JACKSON VILLA CONDOS

4051/4055 JACKSON AVE. CULVER CITY CA

ADMINISTRATIVE SITE PLAN REVIEW APN 4209-001-010 AND 011

ADMINISTRATIVE STAFF
PROJECT REVIEW
06292018

SITE PLAN

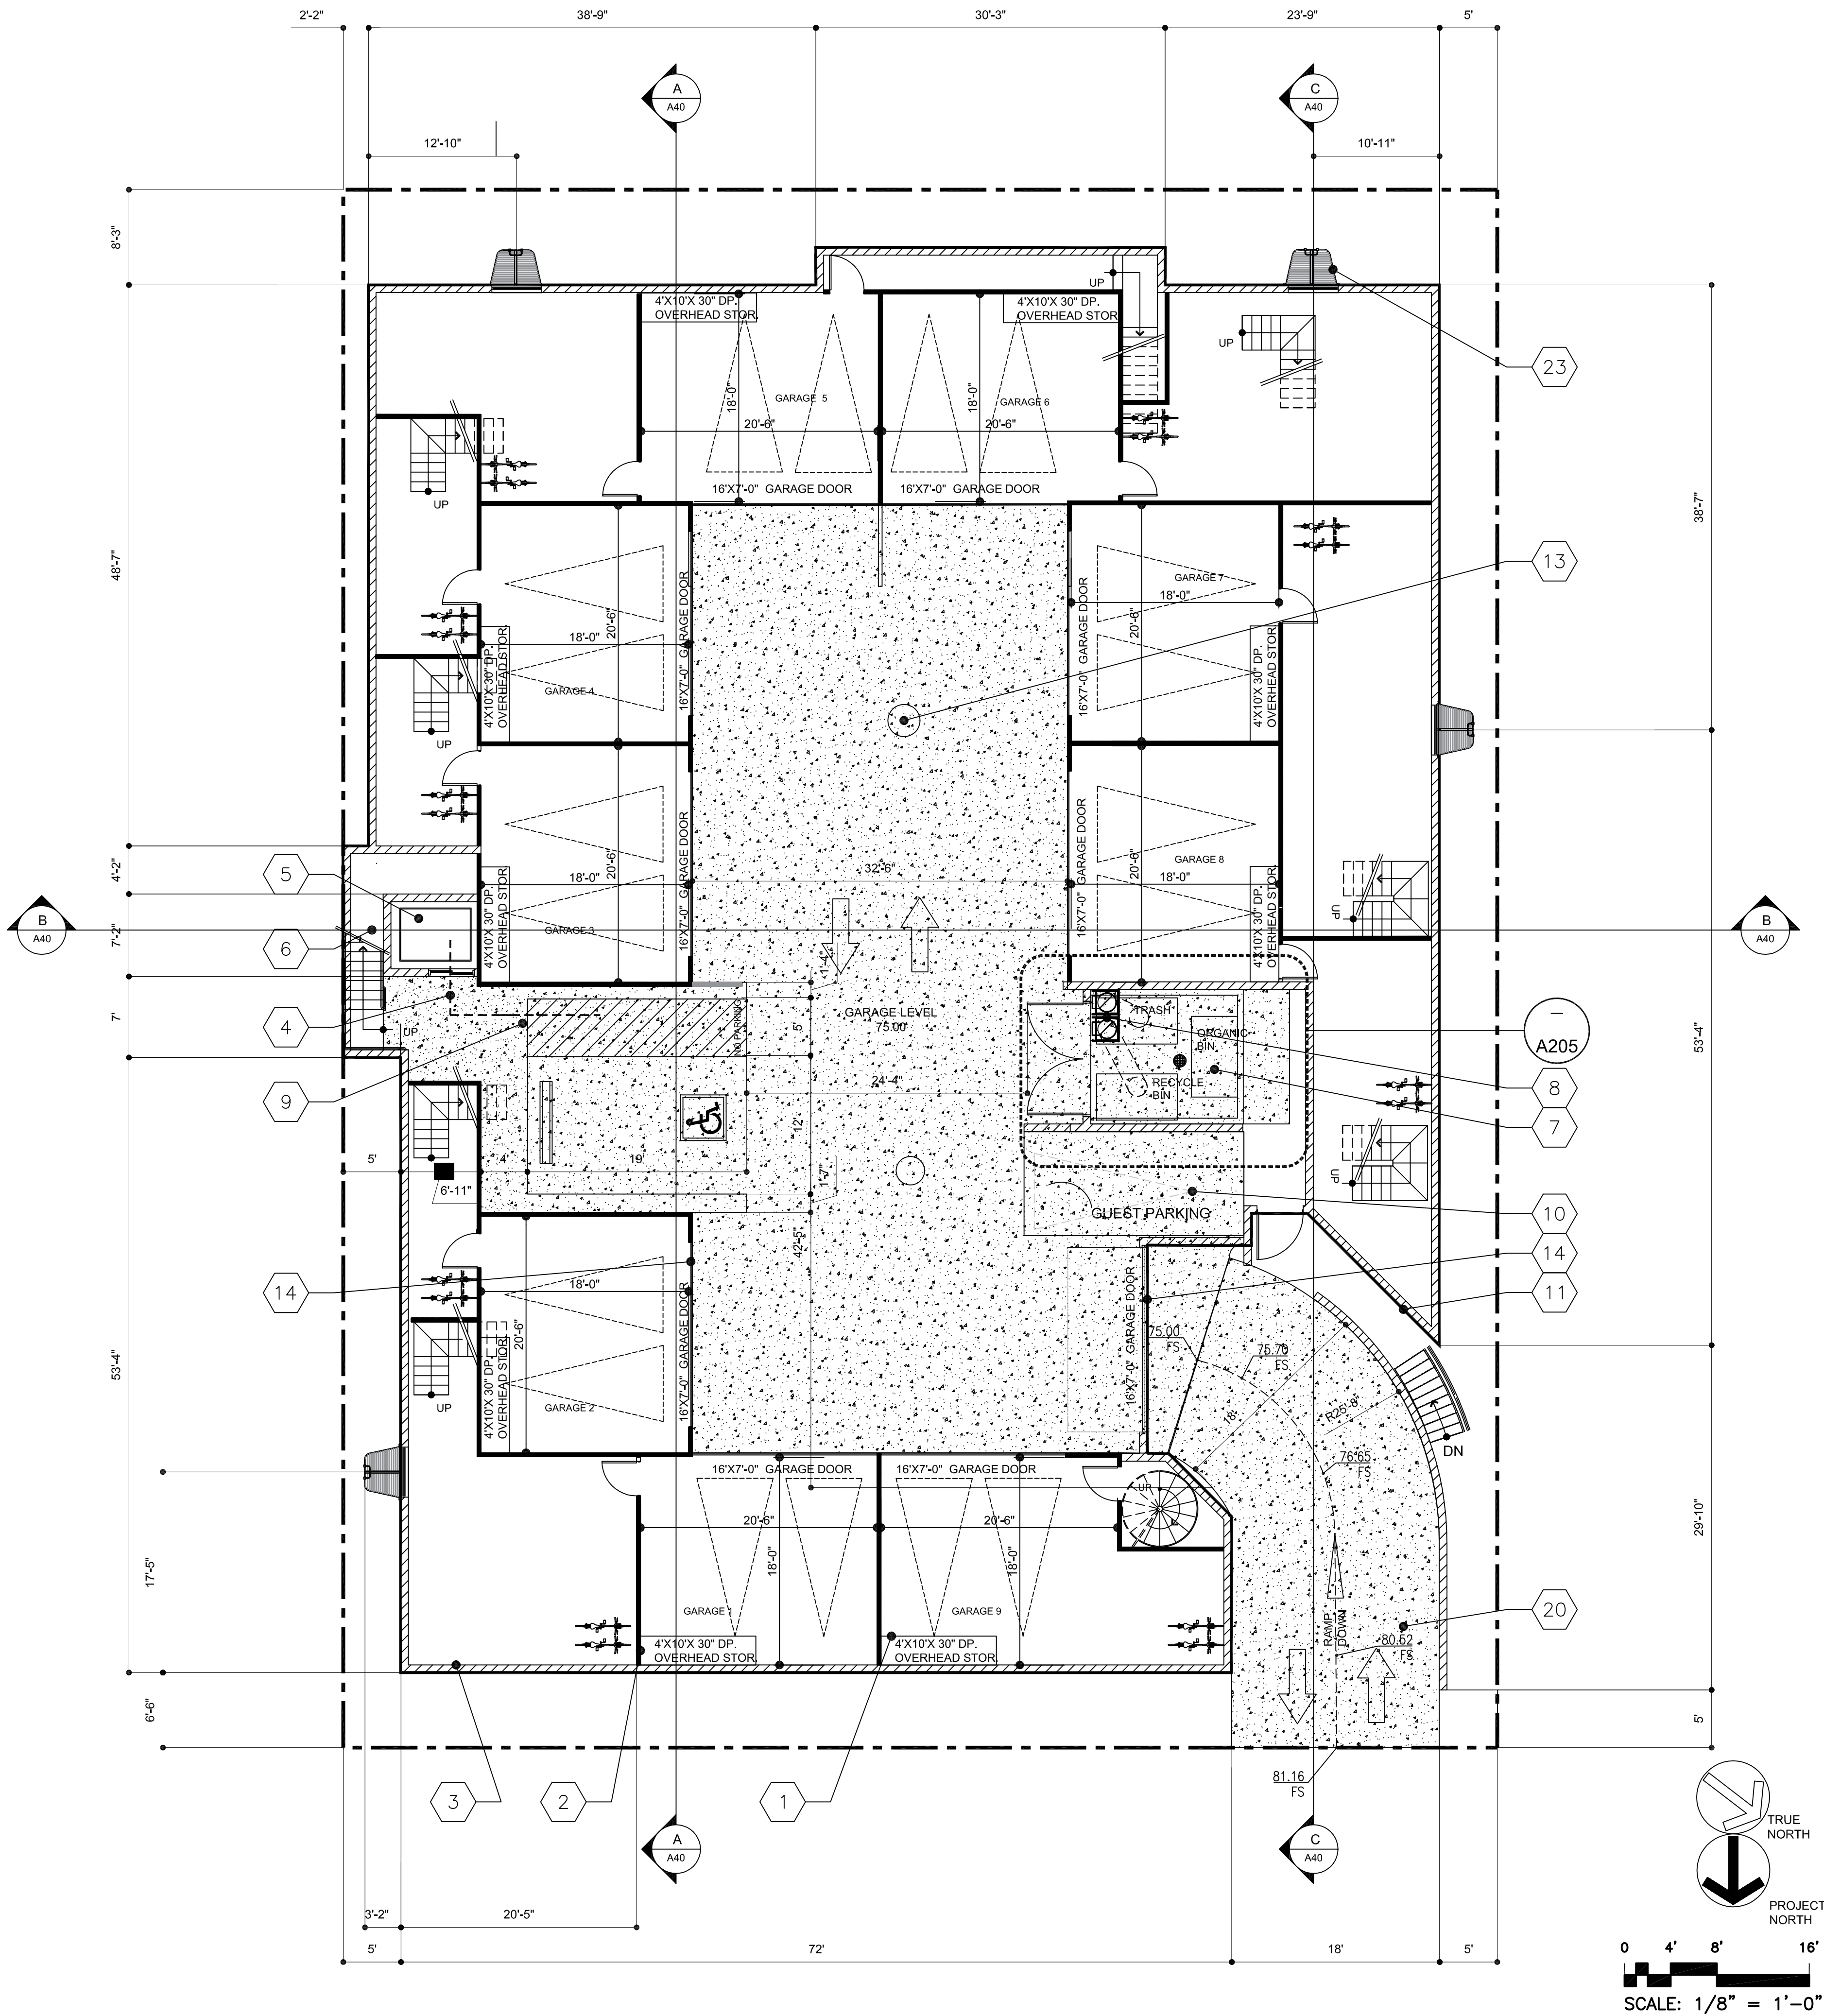
- GENERAL COMMENTS**
- CONNECT NEW SEWER LATERAL INTO EXISTING LATERAL ONSITE. IF NOT POSSIBLE, CONNECT NEW LATERAL DIRECTLY TO THE SEWER PIPE, NOT THE MANHOLE.
 - NO CONSTRUCTION IS PERMITTED WITHIN 5 FOOT SEWER EASEMENT. PLEASE ADJUST A200 SHOWING NO NEW STRUCTURE IN THIS EASEMENT.
 - CONNECT NEW SEWER LATERAL INTO EXISTING LATERAL ONSITE. IF NOT POSSIBLE, CONNECT NEW LATERAL DIRECTLY TO THE SEWER PIPE, NOT THE MANHOLE.
 - NO CONSTRUCTION IS PERMITTED WITHIN 5 FOOT SEWER EASEMENT. PLEASE ADJUST A200 SHOWING NO NEW STRUCTURE IN THIS EASEMENT.
- PUBLIC WORKS - CHRIS EVANS (310) 253-5621**

- SECURE BICYCLE PARKING SHALL BE PROVIDED TO ACCOMMODATE A MINIMUM OF TWENTY (20) BICYCLES, TO MEET THE BICYCLE PARKING REQUIREMENTS FOR THE PROJECT. THE BICYCLE PARKING SHALL BE PROVIDED AS FOLLOWS:
 - TWO (2) SHORT-TERM PARKING SPACES, AND
 - EIGHTEEN (18) LONG-TERM PARKING SPACES (2 SPACES PER UNIT)
- ALL BICYCLE PARKING REQUIRED ABOVE, SHALL BE INSTALLED, MAINTAINED AND MANAGED BY THE DEVELOPER OR THEIR SUCCESSORS, AND APPROVED BY THE PUBLIC WORKS DIRECTOR OR THEIR DESIGNEE, PRIOR TO ISSUANCE OF ANY CERTIFICATE OF OCCUPANCY.

FIRST FLOOR
PLAN

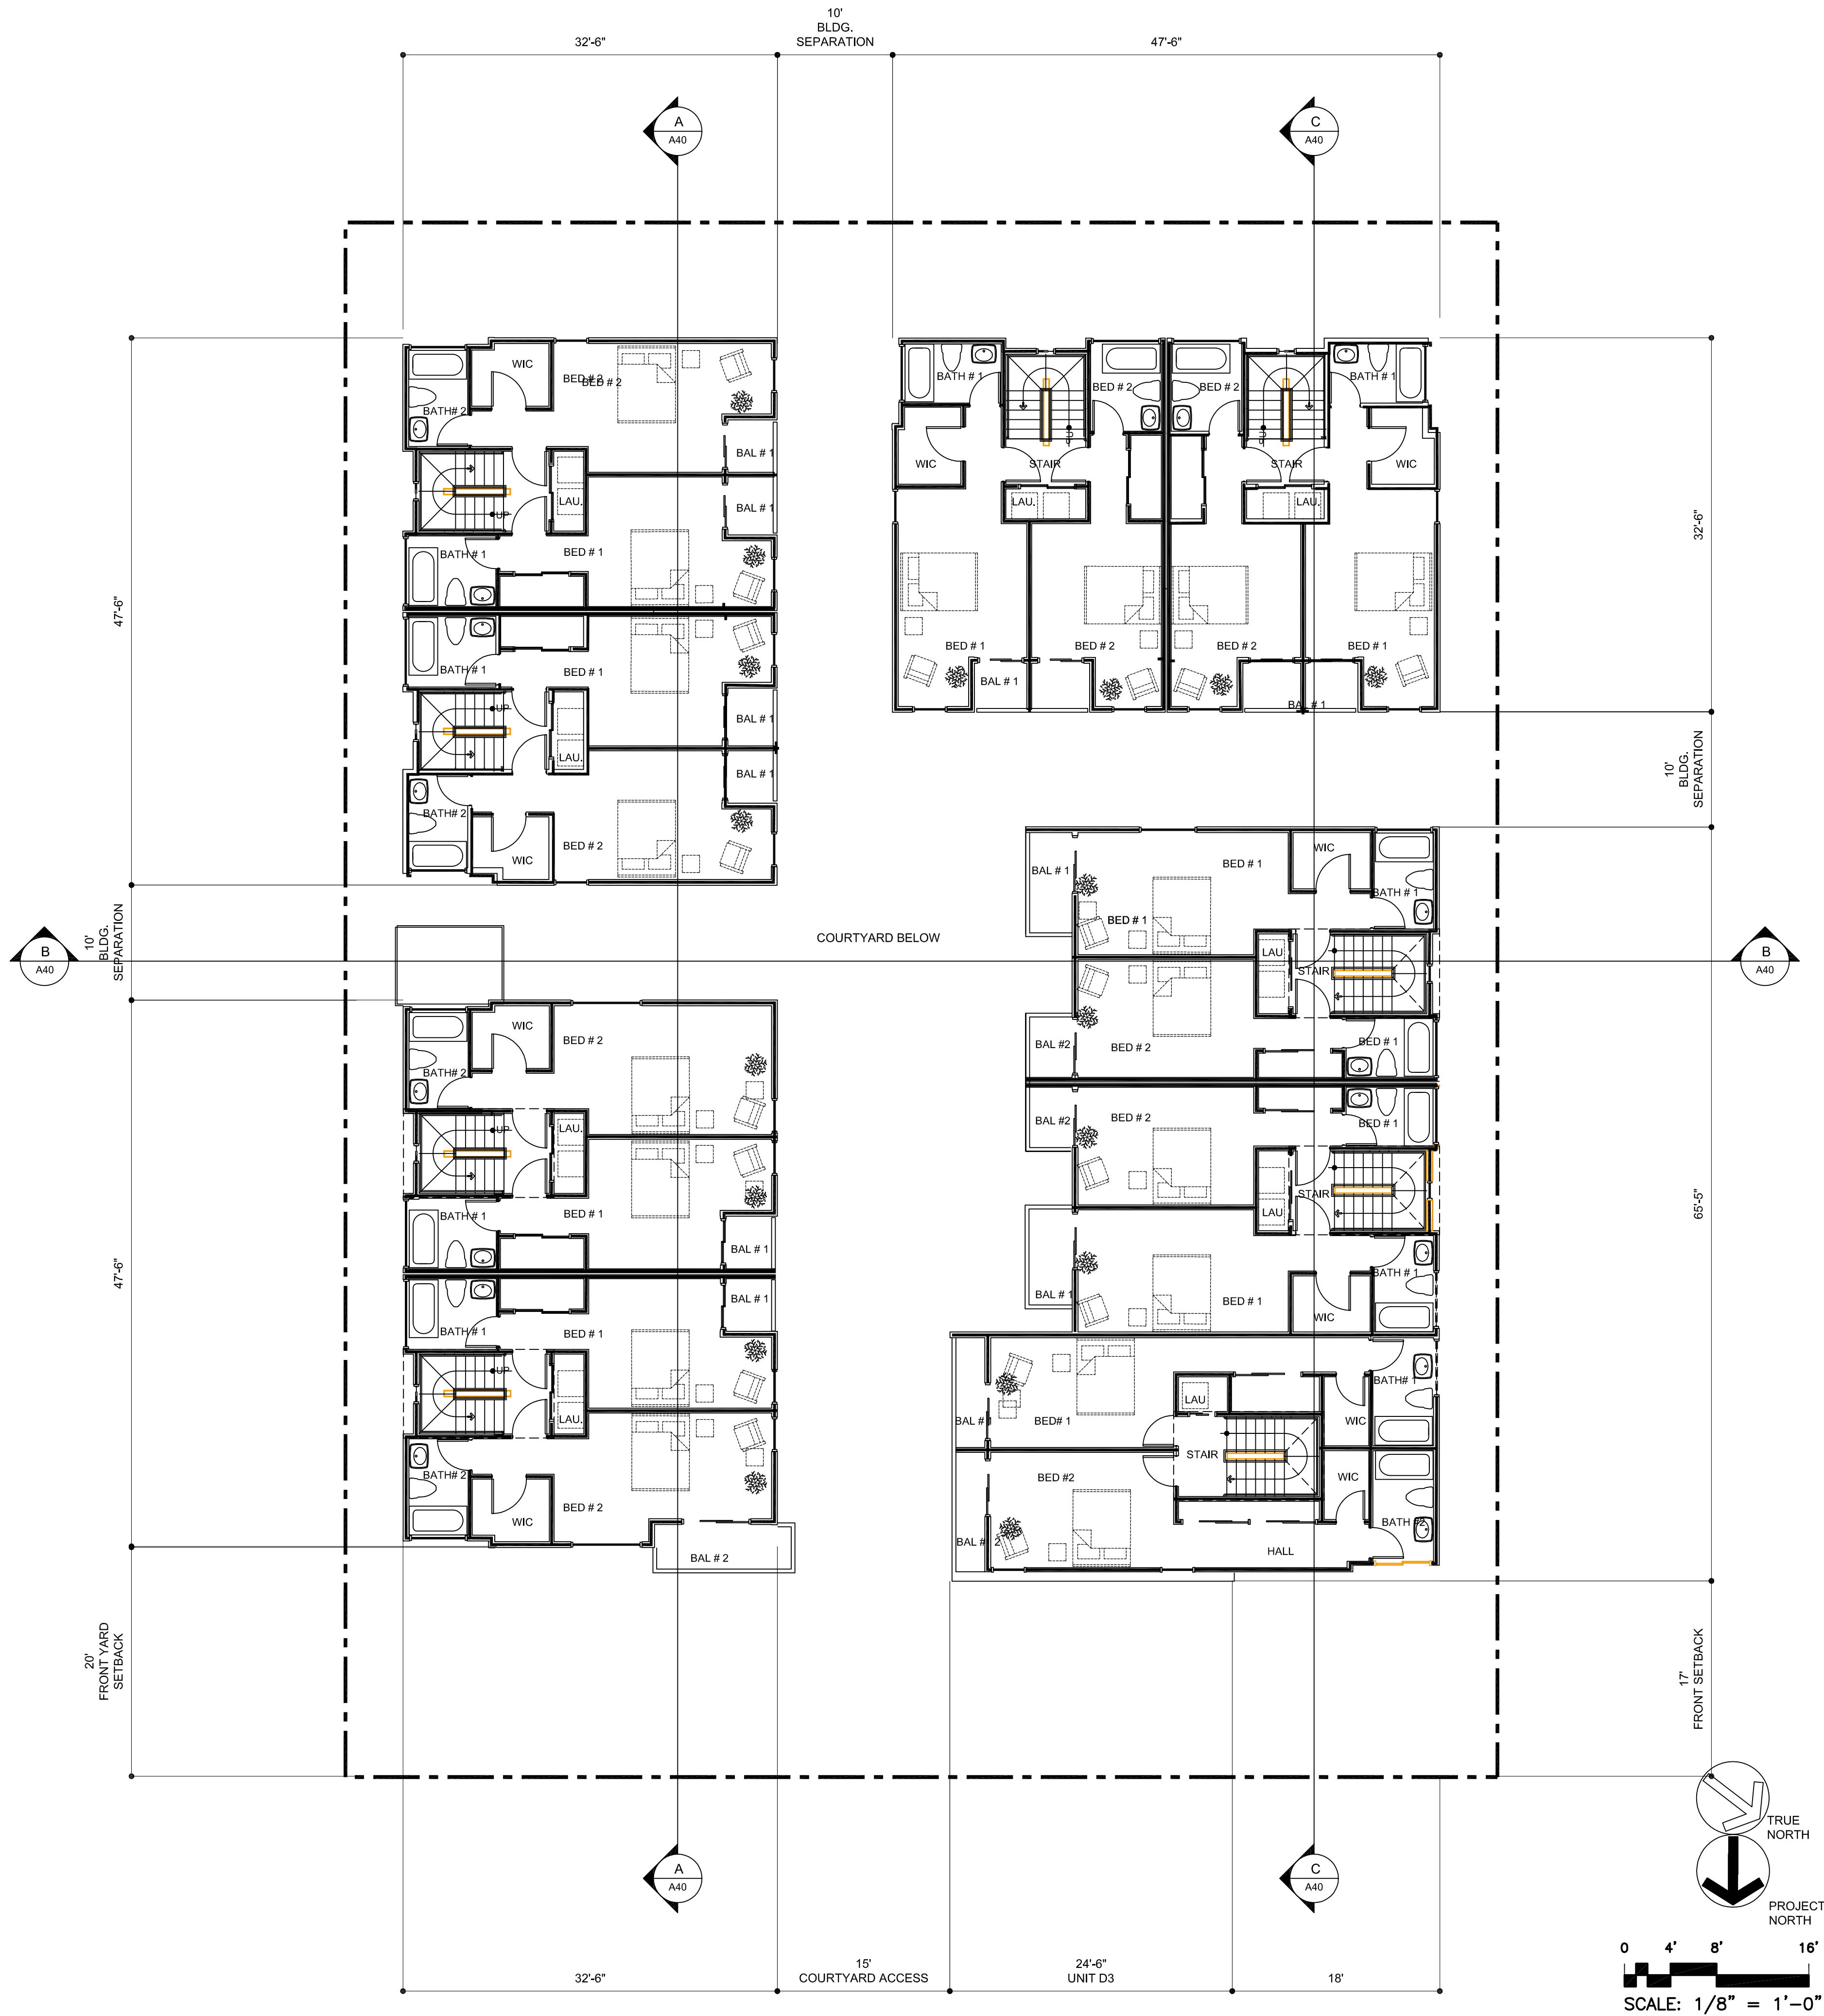
PUBLIC WORKS - CHRIS EVANS (310) 253-5621

1. SECURE BICYCLE PARKING SHALL BE PROVIDED TO ACCOMMODATE A MINIMUM OF TWENTY (20) BICYCLES, TO MEET THE BICYCLE PARKING REQUIREMENTS FOR THE PROJECT. THE BICYCLE PARKING SHALL BE PROVIDED AS FOLLOWS:
 - TWO (2) SHORT-TERM PARKING SPACES, AND
 - EIGHTEEN (18) LONG-TERM PARKING SPACES (2 SPACES PER UNIT)
2. ALL BICYCLE PARKING REQUIRED ABOVE, SHALL BE INSTALLED, MAINTAINED AND MANAGED BY THE DEVELOPER OR THEIR SUCCESSORS, AND APPROVED BY THE PUBLIC WORKS DIRECTOR OR THEIR DESIGNEE, PRIOR TO ISSUANCE OF ANY CERTIFICATE OF OCCUPANCY.
